Applies To: **2007 Element With 2WD** – From VIN 5J6YH1...7L000001 thru 5J6YH1...7L007749
2007 Element With 4WD – From VIN 5J6YH2...7L000001 thru 5J6YH2...7L005730

Front Passenger's Seat Base Cover Is Loose

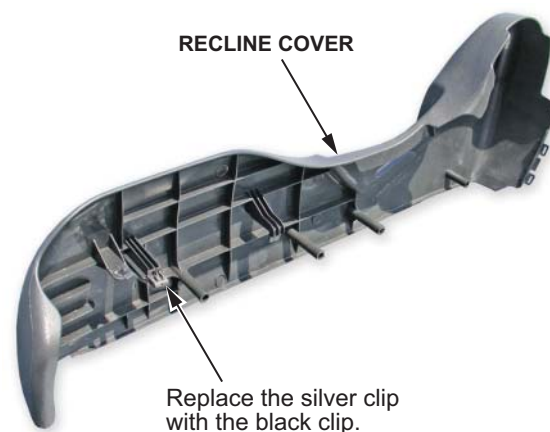
The recline cover on the base of the front passenger's seat is loose.

The clip on the cover is not strong enough to hold it in place.

Replace the clip with an improved part, or replace both the cover and the clip if the cover is damaged.

2. Inspect the cover for damage:
 - If the cover is not damaged, replace the silver trim clip with a new black clip, and reinstall the cover (*do not replace it*).
 - If the cover is damaged, replace it (it already has the new clip attached).
